ADDENDUM NO. 2

Reference: Student Activity Center Addition to the Stromberg Athletic Complex
Weber State University – Ogden, Utah
DFCM Project No. 12031810

Addendum 002

project:	WSU Stromberg Student Activity Center	**project no:**	12475
date:	2012-10-15	**no. pages:**	75
owner:	DFCM		
contractor:			
bid date:	2012-11-01	**bid time:**	12:00 pm

M117.1

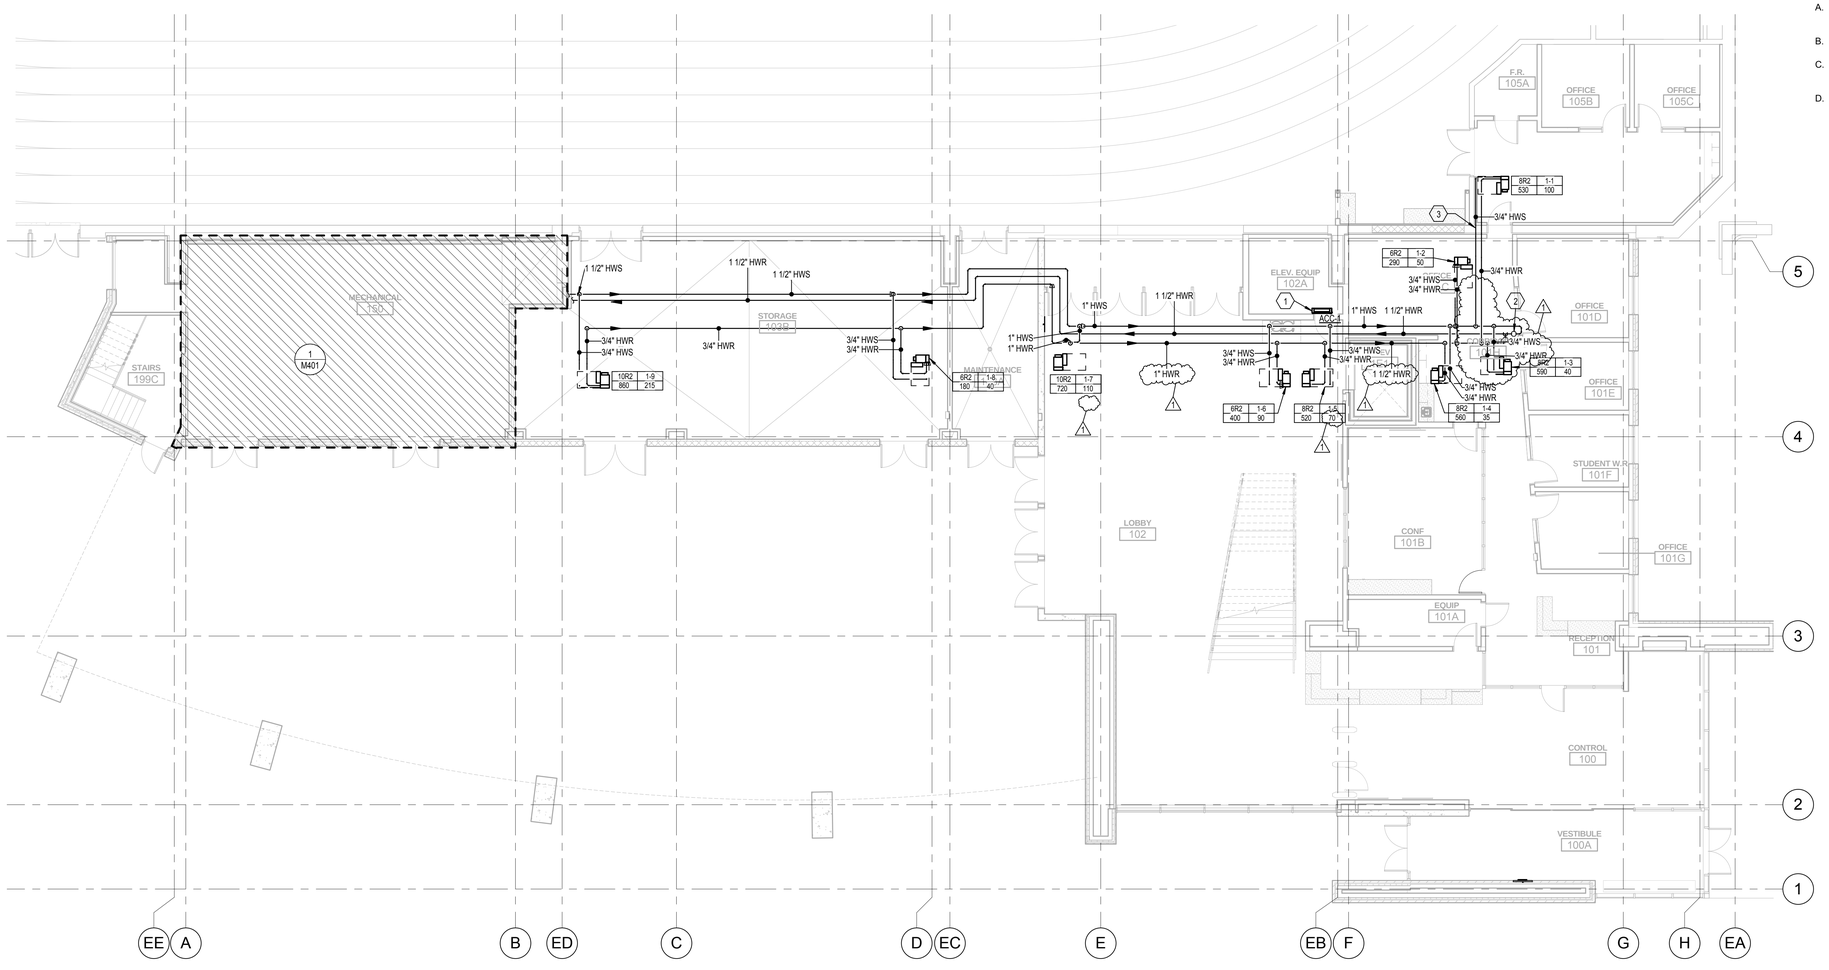
14.	Clarify	M117.1	• Clarify HW pipe size. • Clarify VAV tag CFM.
15.	Clarify/Add/ Delete	P401	• Add FD to second floor waste and vent isometric. • Add condensate pipe to AHU-1 on enlarged mechanical room plumbing plan. • Add Keyed note #2 and #3. • Delete DF-1 from second floor waste and vent isometric. • Delete VFD-2. • Adjust FD location and pipe sizes.
